WLTP UNR Development (based on WLTP-28-09e)

Agreed proposals within WLTP Sub Group EV

Figure A8/2

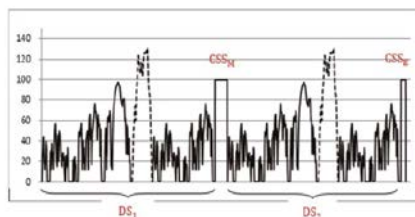
Update/amendment of Annex 8, Paragraph 3.4.4.2.1.2. (constant speed segment)

- In the referred paragraph, it is only described how to accelerate to reach the speed in the constant speed segment but it is not described how to decelerate
- Proposal adds a sentence which also describes how to decelerate from constant speed to stand still

The deceleration from the constant speed level shall be smooth and accomplished within 1 minute after completion of the constant speed segments.
